Resource consent application – s92 request

Application number:	LUC60397719
Applicant:	Watercare Services Limited
Proposed activity:	The provision of minor infrastructure upgrades that are located within flood plains, overland flow paths, or areas of coastal inundation
Site address:	Various sites throughout Auckland associated with the consented central interceptor project

Minor Infrastructure in Natural Hazard Areas: Response to s92 Request for Further Information in relation to Watercare's Resource Consent Application LUC60397719

Minor Infrastructure upgrades associated with the CIP: Response to s92 Request for Further information relation to Watercare's Resource Consent Application LUC60397719.

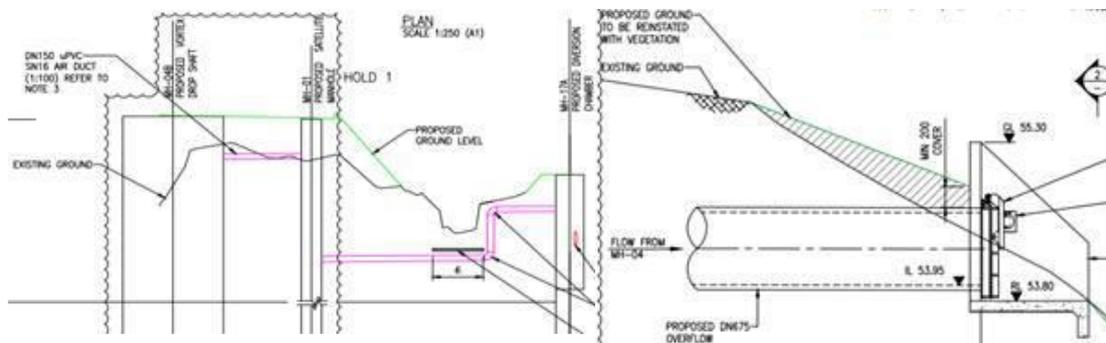
4. Following on from question 3, please provide clarity on the total volume and depth of fill proposed within the flood plain.
5. Please provide evidence to support the statement that there 'be no exacerbation of existing flood risk' (Table 6.2 c within the assessment of environmental effects (**AEE**)), noting that the consent includes filling works within a flood plain which has not been addressed as part of the risk assessment and may result in a loss of available flood storage ,which would likely exacerbate flood risks offsite.

Note: sections are provided below that show areas where filling is proposed:

- Please provide evidence to support the statement that there 'be no exacerbation of existing flood risk' (Table 6.2 c within the assessment of environmental effects (AEE)), noting that the consent includes filling works within a flood plain which has not been addressed as part of the risk assessment and may result in a loss of available flood storage, which would likely exacerbate flood risks offsite.

Note: sections are provided below that show areas where filling is proposed:

As outlined above earthworks are authorised under the existing CI designation and resource consents.

The effects of flooding at this site (May Road) are managed under consent 40840, condition 6.3 that requires a Stormwater Management Plan to be prepared that includes a description of how the 100 Year ARI attenuation to pre-development levels objective at that site will be met (see **attachment 2** for complete condition). Note that condition 6.3 applies to a number of CI sites and includes consideration of how stormwater flows in excess of the primary system are provided for, up to the critical stormwater event with a 1% Annual Exceedance Probability (RC6.3(f)) and effect of site development on overland flow paths (RC6.3(g)).

SECTION 1
SCALE: 1:50

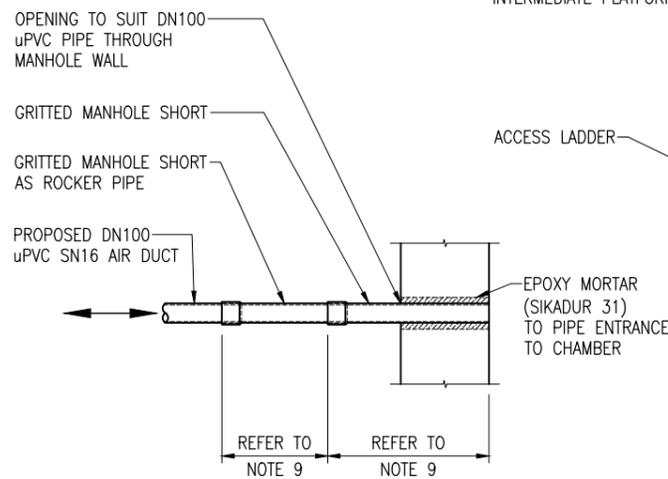
2. Please confirm if the above ground stairs at May Road referenced in section 3.3 of the submitted assessment of environmental effects refers to the access ladder shown in Section 1 in the MH-17A Diversion Chamber – Sections drawing, drawing number 2011806.006, issue E, dated 22 January 2021. If not, please provide details and any necessary level of additional assessment.

2. *Please confirm if the above ground stairs at May Road referenced in section 3.3 of the submitted assessment of environmental effects refers to the access ladder shown in Section 1 in the MH-17A Diversion Chamber – Sections drawing, drawing number 2011806.006, issue E, dated 22 January 2021. If not, please provide details and any necessary level of additional assessment.*

The proposed stairs do not refer to the access ladder. The above ground stairs are shown separately and have an approximate footprint of 13m².

Attachment 1: Keith Hay Park Site Plan

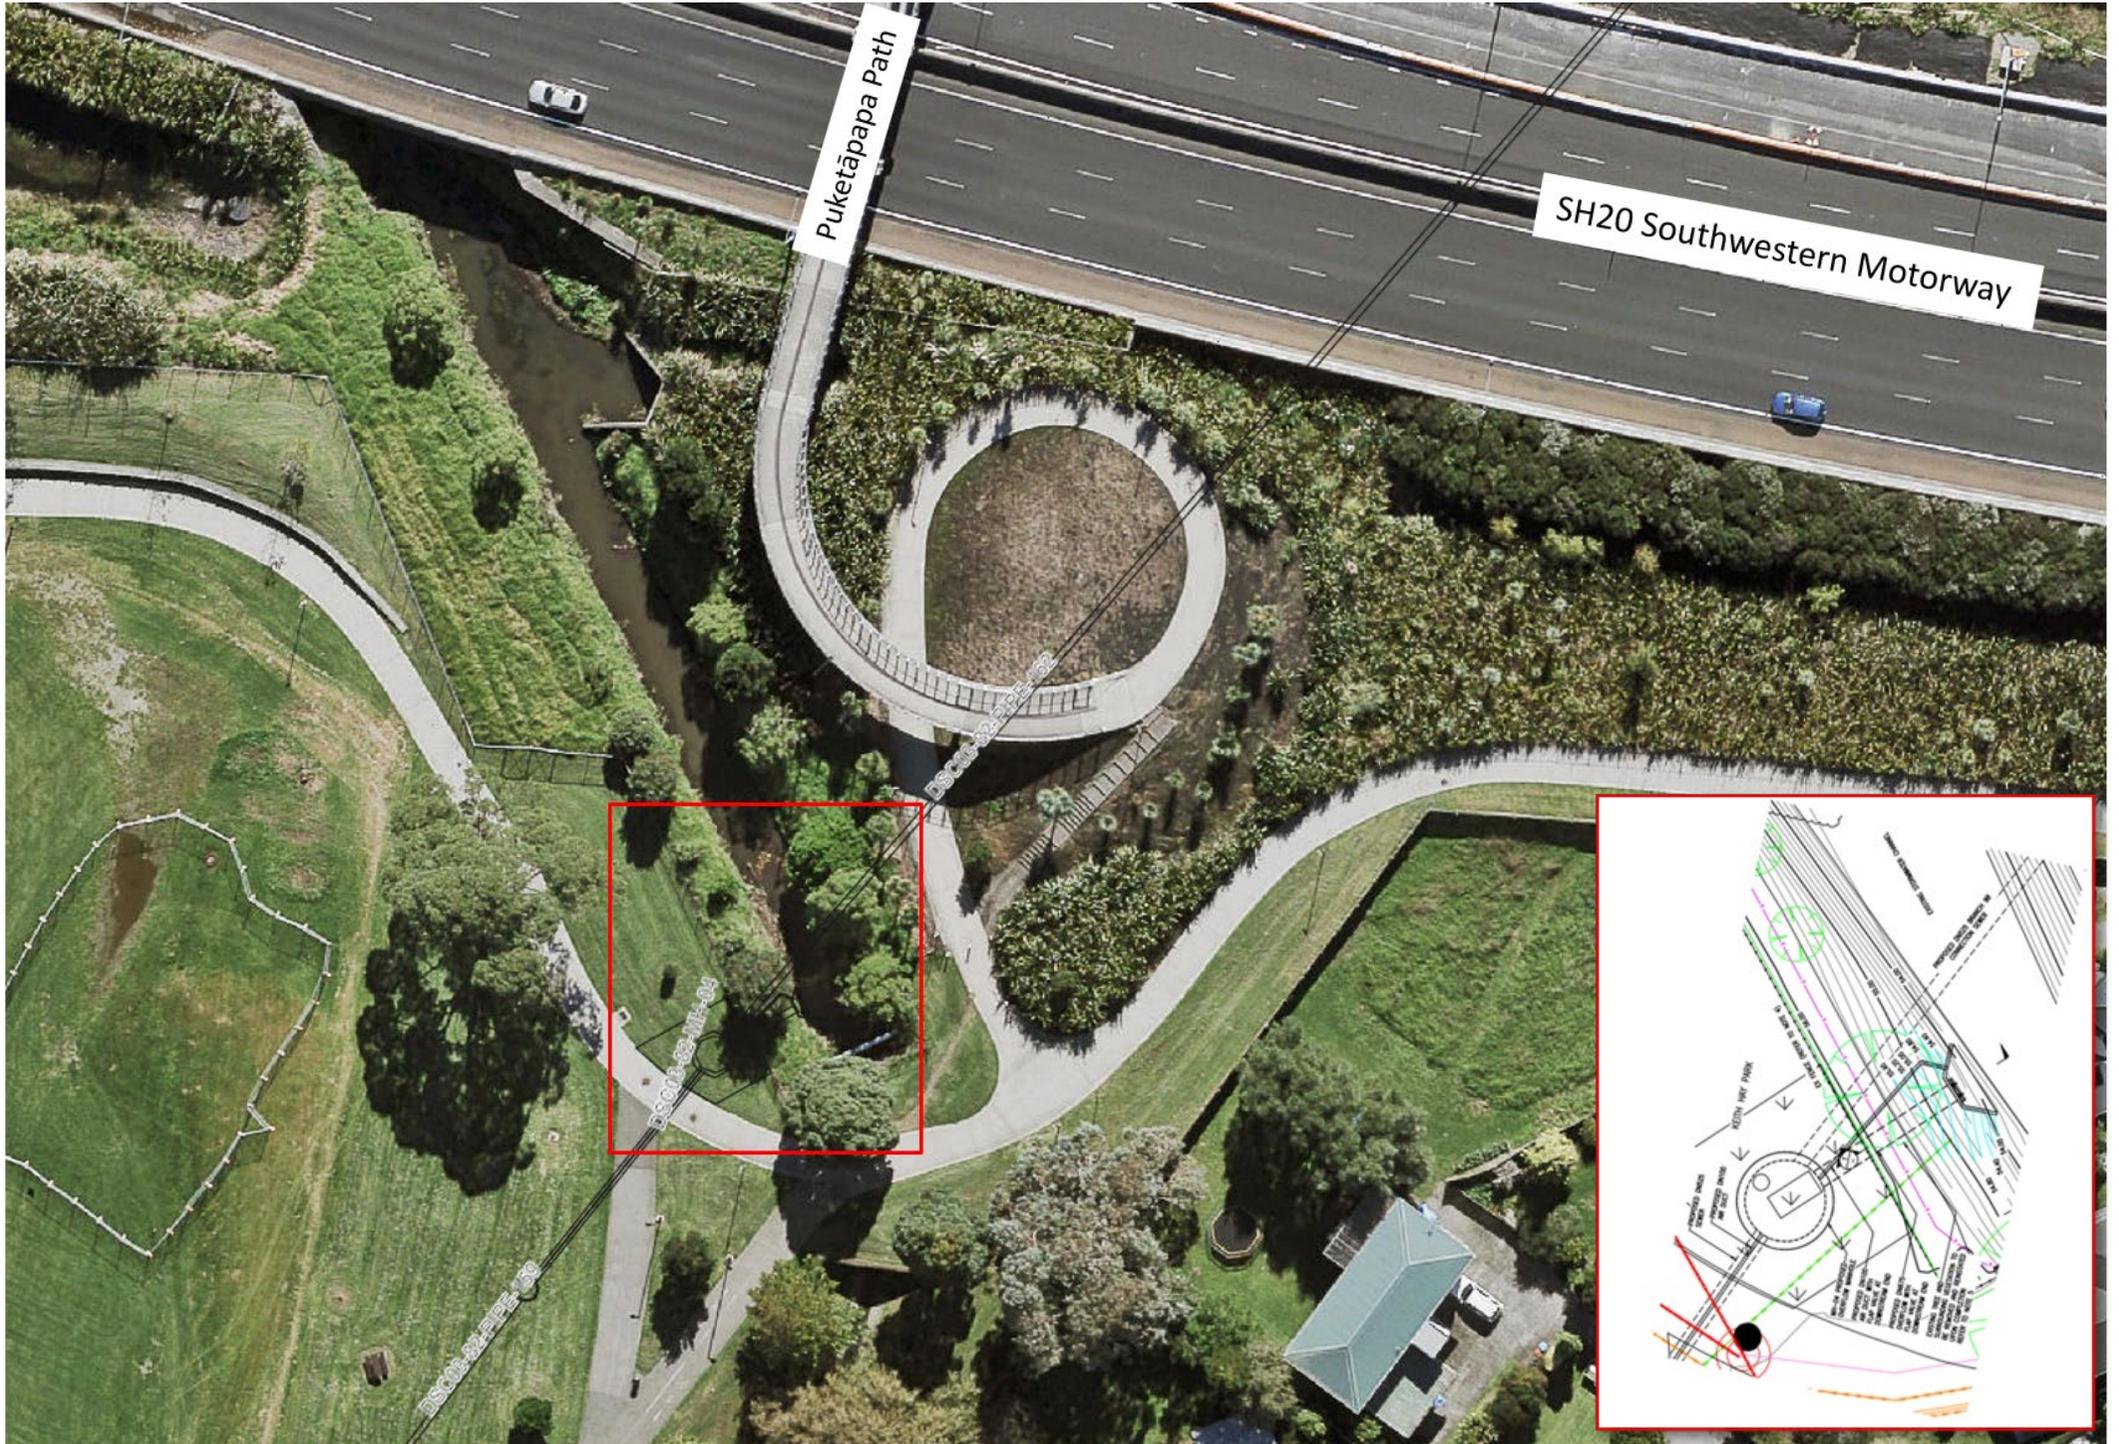
1. Please clearly show on a site plan the location of the Keith Hay Park works. For reference, the overlay of the proposed works at May Road is shown on drawing number 2011806.003, issue F, dated 11 January 2021. This level of detail needs to be replicated with the plan of works for Keith Hay Park.

1. *The plans provided include sections of the manholes but does not show their location. For reference, the plan at May Road shows the site relative to the proposed works. While this is shown for Keith Hay Park, they are zoomed-in, and the exact location cannot be identified. The s92 response just provides some sections of the manhole.*

Please find attached a copy of Keith Hay Park proposed site provided in **Attachment 1**.

This proposed site plan shows a zoomed-out view of Keith Hay Park and some of the surrounding land marks for reference to location, including the snippet provided in the email.

Figure 3 Coastal Inundation Zone from Auckland Council GeoMaps

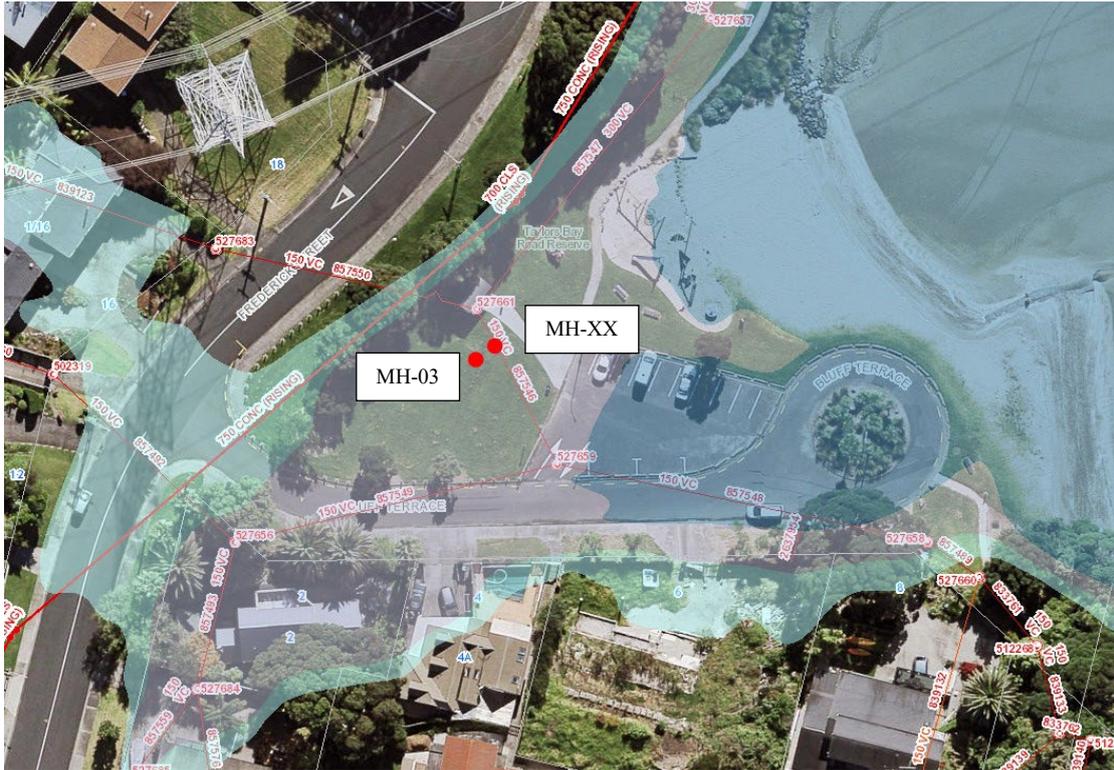
2. *The Council needs to be able to confirm that all structures within coastal inundation areas will be designed to minimise surface water and seawater ingress and that infrequent operator access is anticipated (or will be managed to minimise risk). This confirmation cannot be found in the application documents and if it can be provided, this will circumvent the need for an E36.9 assessment. Accordingly, the request is reiterated to provide clarity where works are subject to coastal inundation and what measures are proposed to mitigate the effects of coastal inundation on the infrastructure and its serviceability.*

The Council needs to be able to confirm that all structures within coastal inundation areas will be designed to minimise surface water and seawater ingress and that infrequent operator access is anticipated (or will be managed to minimise risk). This confirmation cannot be found in the application documents and if it can be provided, this will circumvent the need for an E36.9 assessment. Accordingly, the request is reiterated to provide clarity where works are subject to coastal inundation and what measures are proposed to mitigate the effects of coastal inundation on the infrastructure and its serviceability.

The proposed access hatch levels for MH-XX and MH-03 are 3.30mRL and 3.38mRL, respectively, which are above the 100-year ARI storm event maximum extreme sea level.

Adding 1 metre of sea level rise due to climate change onto the extreme sea levels results in both MH-XX and MH-03 access hatches being submerged at times.

MH-XX and MH-03 cannot be relocated to be outside of the extreme sea level & 1 metre of climate change area. They must be located where designed to enable the connection to the existing sewer, which ultimately allows for the rehabilitation or decommissioning of the Western Interceptor.

Both manholes will be fitted with one sealed access hatch each to minimise the ingress of seawater through these hatches. Operator access to these manholes will be very infrequent.

MH-XX and MH-03 will be buried approximately 150mm below the existing ground level. The access hatches will be visible from the ground surface and will be set flush with the existing ground level. The surface will be reinstated with topsoil and grass.

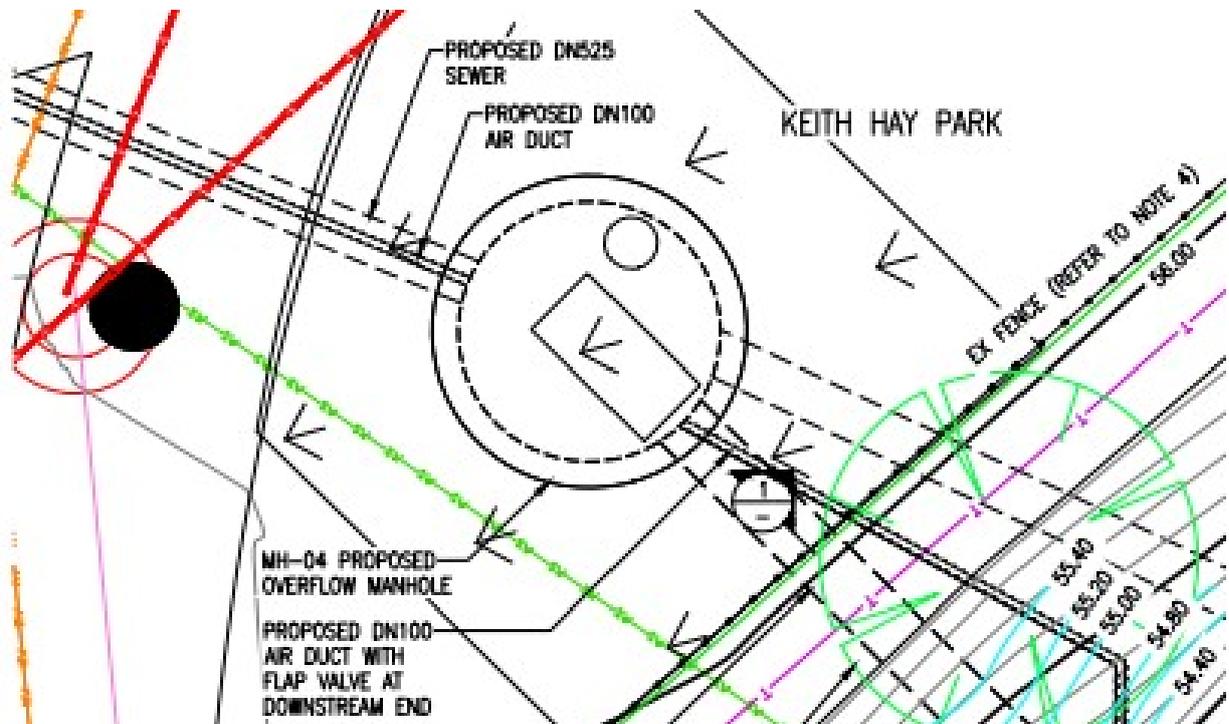
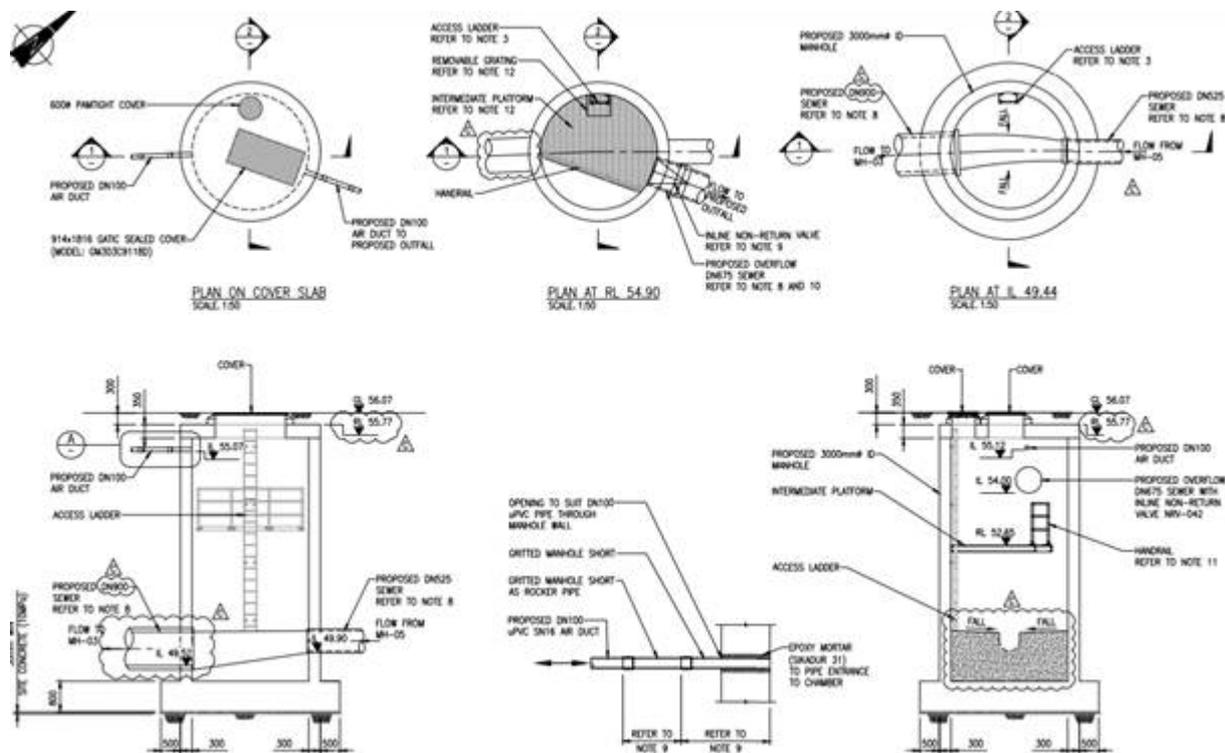
The plans provided include sections of the manholes but does not show their location. For reference, the plan at May Road shows the site relative to the proposed works as per the snip below:

While this is shown for Keith Hay Park, they are zoomed in and the exact location cannot be identified, see snip below:
